REGULAR MEETING OF THE BIRMINGHAM PLANNING BOARD

WEDNESDAY JUNE 26, 2024 – 7:30 PM

Preliminary designs for construction of the Booth Park Entry Plaza & Trail Improvements are currently underway and being routed to the appropriate boards and committees for review and comment.

SUBJECT: Booth Park Entry Plaza and Trail Improvements – Preliminary Park Design and Concepts Plan

Preliminary Design
Landscape Plan
06.26.2024

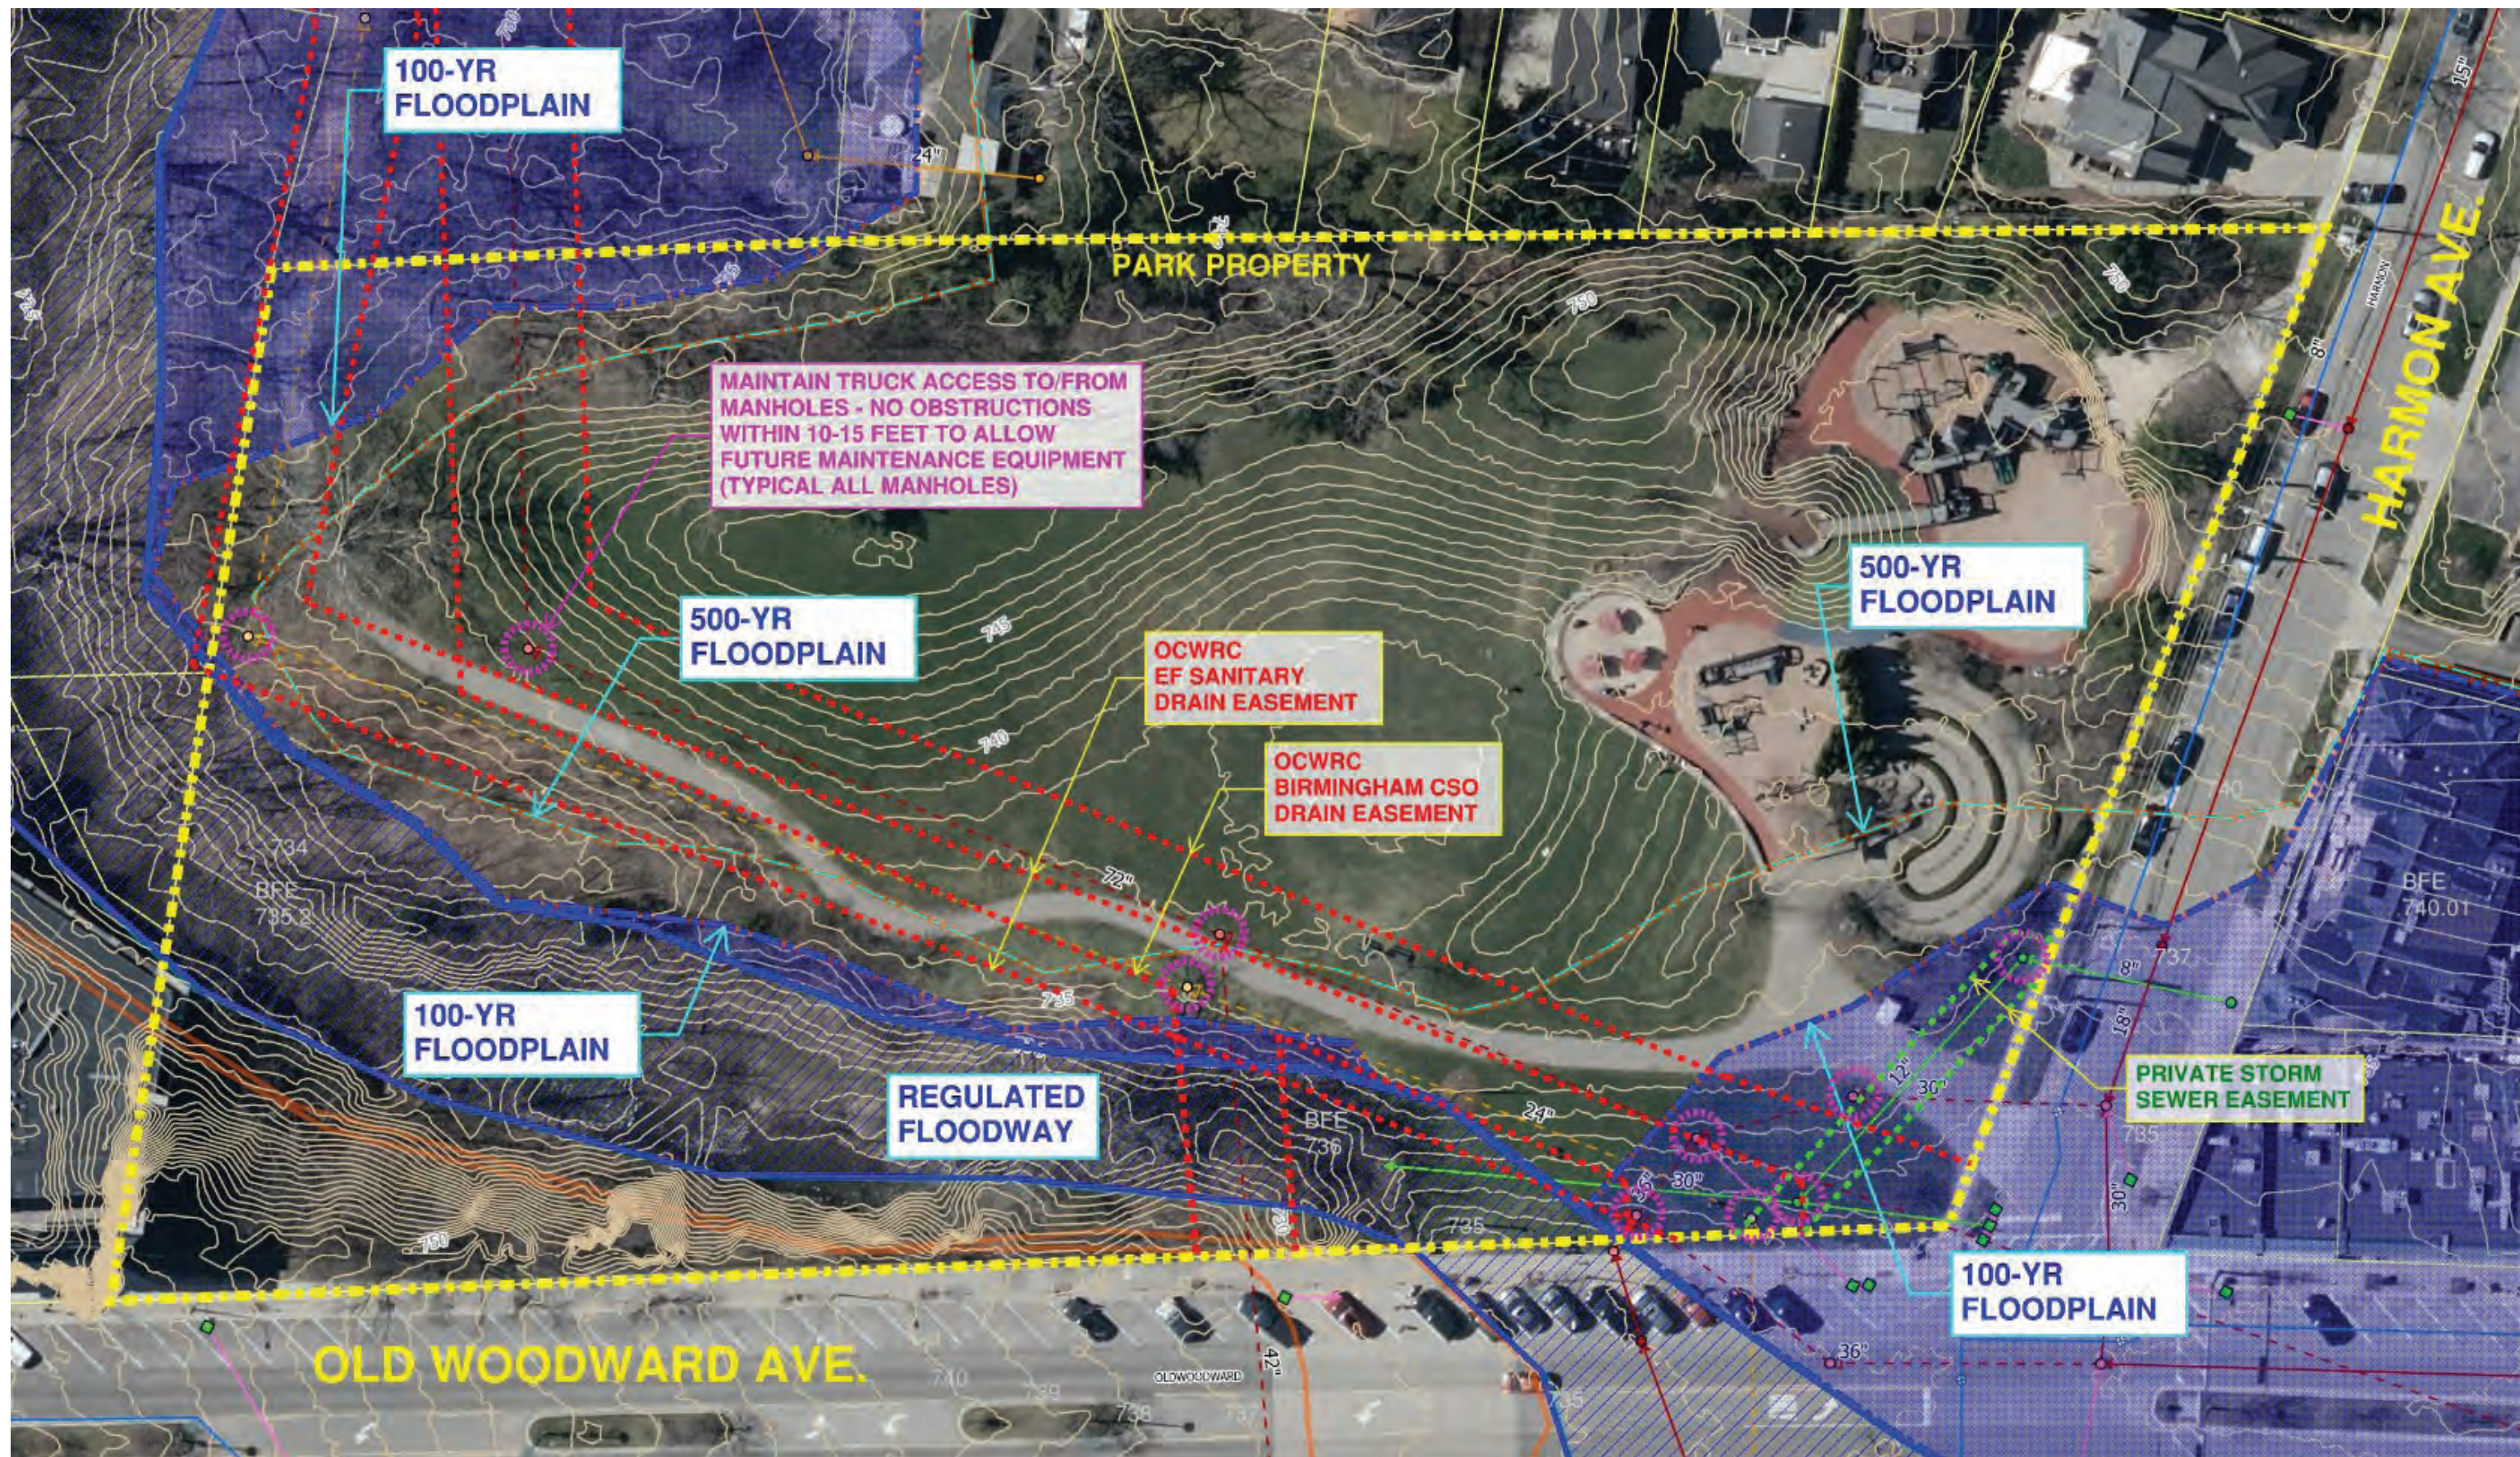
I have some concerns over our ability to see into the park. This is an area that is a teen hangout on the evenings, particular on the weekends. Due to the play structure, it can already be difficult but with the additional trees and restrooms and other features it will be impossible to check the park without walking through it. Currently we only have one camera at this location but I would request possibly as many as two additional cameras to provide the ability to check the park. These locations would need power supply. We can look at potential locations, but maybe your designers can add some insight in terms of future site lines once constructed and the ability to construct with a power supply in place.

- **I think the hammock idea is great.** I personally like the rope-style because it is simpler, easier to remove or replace, and visually has a lower profile in the natural surroundings.

- **Splash pad...** Is it just a random idea, or is it planned for the playground area? I'm not a fan of splash pads...they seem costly and not used enough to be worth the effort, running water lines, etc. if it is inevitable, it seems like it could have a smaller footprint, possibly integrate with the garden areas so the water drains off and has a secondary purpose. Also, I think splash pads are begging for shade for little kids and/or their adults to get relief from hot sun. If not natural shade, maybe a pergola or structure of some kind, or even an awning arrangement. (A small fountain or splash pool would potentially have other uses/purposes than just a splash pad, but I know they have maintenance issues, too.)

- **Interpretive signage, new canopy trees, etc.** I vote for interpretive signage that uses QR codes, which allow flexibility for whatever the content is...environmental/native plants and animals, sustainability, and naturally, I think a little history would also be cool 😊. QR symbols can be changed out if needs change over time and are much less costly to install than permanent signs. As for canopy trees, the area is not very big, but what about a grouping of mixed native trees and underplantings with interpretive QR codes? Possibly the foundation of an arboretum?

In February, I provided a detailed memorandum (attached) regarding the specific objectives of the Birmingham Plan 2040 as they relate to this project, which involved the park space as well as the Rouge River corridor. Fortunately, I believe that the concept plans address most, if not all of the recommendations related to the park space that I quoted from the 2040 Plan. The plans contain much more seating, café/vendor accommodations, restrooms, and the paved plaza that has been a goal of ours since the Downtown Birmingham 2016 Plan. At this time, I would only feel the need to encourage further the use of pervious paving materials, whether it is pavers or otherwise. In my opinion, this should absolutely be done in areas "1" and "4" which contain seating, but would be encouraged along what is now labeled as the 10' wide concrete path. Perhaps small accent portions could be introduced with pervious pavers.

- Every new or improved landscape bed as a part of this project, as well as future projects along this trail, should without exception be native plantings, and all new trees should be native species. In my opinion, this should be clearly stated in the "Note Key" in items such as 8, 15, 16, 23 and 24. This may already be the approach, but I believe that being explicit with our intentions will go a much longer way.

- The trail gateway signage and the acknowledgement to the recently approved Wayfinding and Signage Master Plan is well received. Any new sign design will need to go before the Wayfinding and Branding Committee, but my initial reaction is very positive.

- There is currently a piece of public art located near the entrance that is not noted on this plan. I have been advised that the City has asked the artist to remove the piece, but it could be noted on this plan that the art is going away as to not confuse anyone. In addition, the Planning Department would be supportive of alternate displays of public art, the possible placement of such could be added to this plan to give direction to staff when considering future donations or loans.

- I do not see any lighting as a part of this plan, but if there becomes a need (even just small fixtures to illuminate signage), the fixtures should be solar powered. I would also encourage anything else that requires power to be solar powered, or at a minimum be constructed to be able to accommodate solar at a future date.
